From:	Russ
To:	Melissa Sonnek
Cc:	Jim Hartshorn; Larry Koland
Subject:	RE: More Space Oakdale Avenue
Date:	Monday, October 5, 2020 9:51:03 AM
Attachments:	image002.png image003.png image004.png image005.png image006.png

More Space Self-Storage

Planning Review Summary

RESOLUTION APPROVING A SITE PLAN FOR THE CONSTRUCTION OF A SELF-STORAGE FACILITY AT 1665 OAKDALE AVENUE - MORE SPACE, LLC

A1 / CS01 Site Plan
1" = 20'-0"

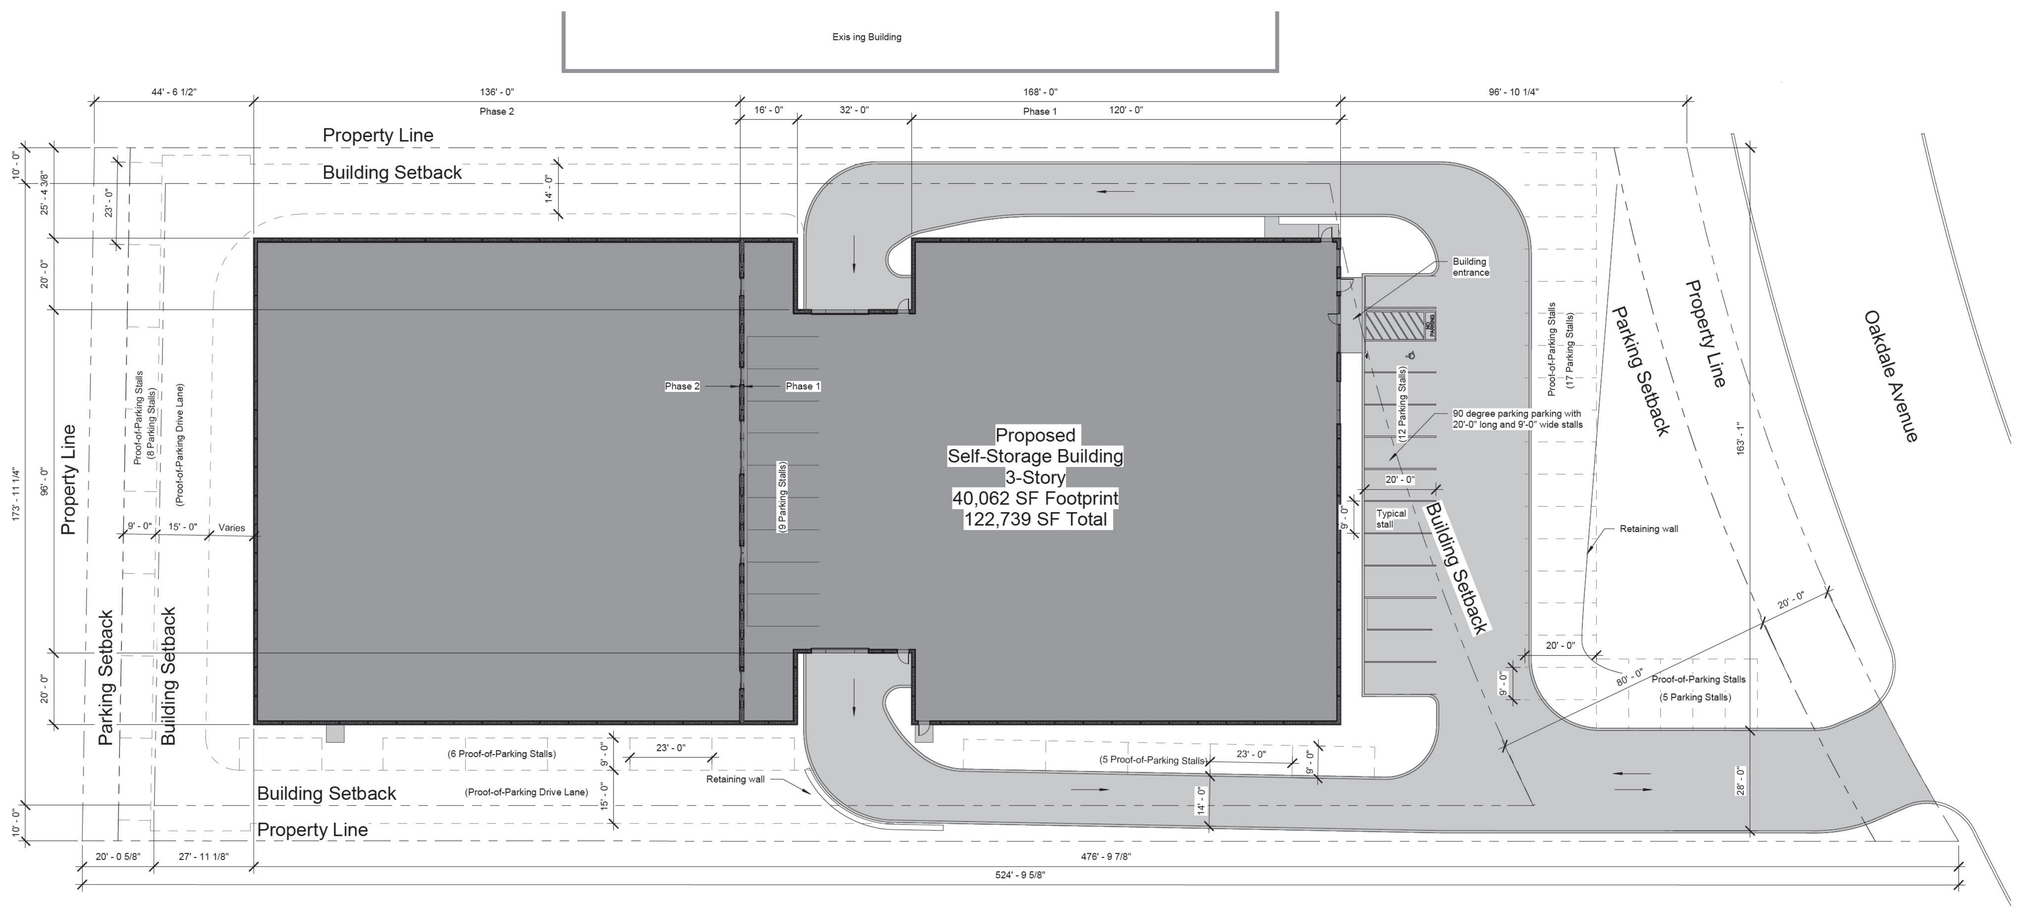
9. The Applicant shall enter into a storm water management agreement prior to the application of a building permit;
10. The Applicant shall adhere to all items outlined in the Dakota County Plat Commission dated March 16, 2020;
11. The Applicant shall work with City Staff to reduce the number of parking stalls to proof of parking along the front building façade to incorporate more trees; and
12. The Applicant shall work with City Staff to address the soil and elevation concerns mentioned by an adjacent property owner.

Landscape Plan

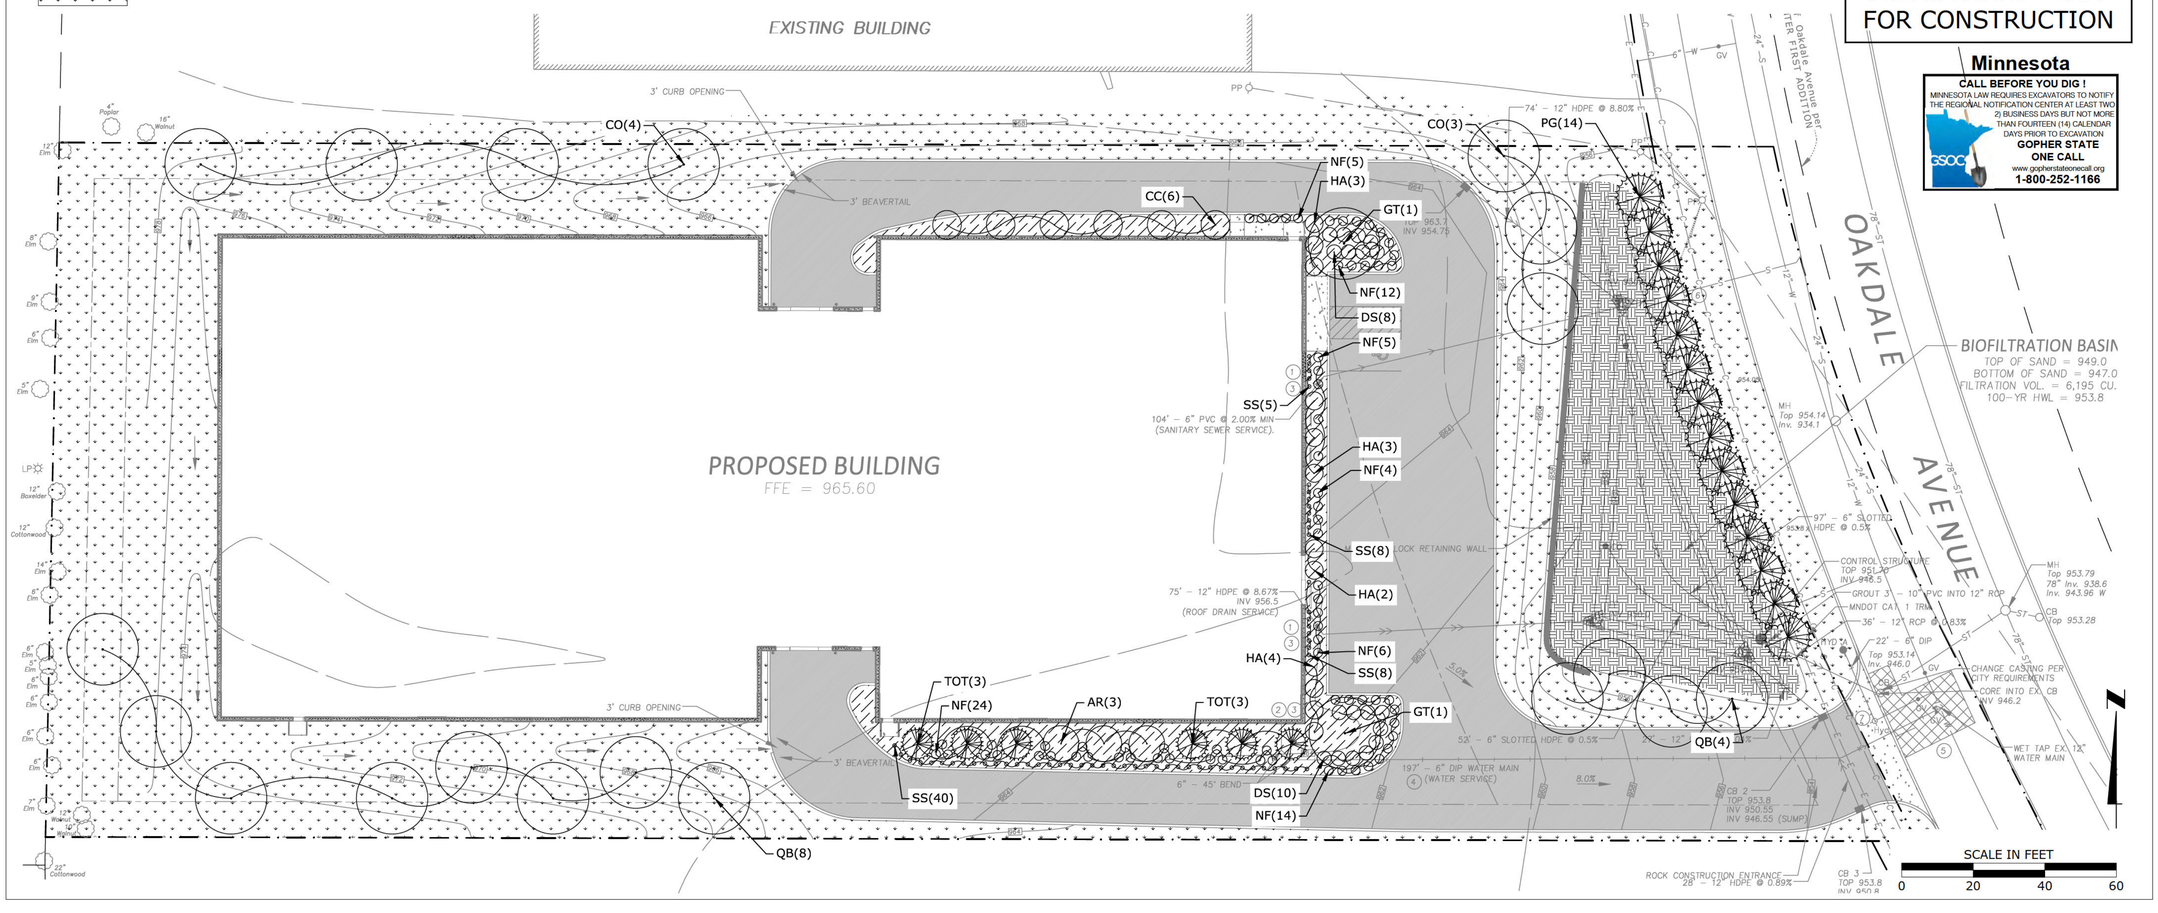
4. The Applicant revise plans to either increase the number of trees or increase the caliper inches of the proposed trees to meet the 222 caliper inches minimum requirement;
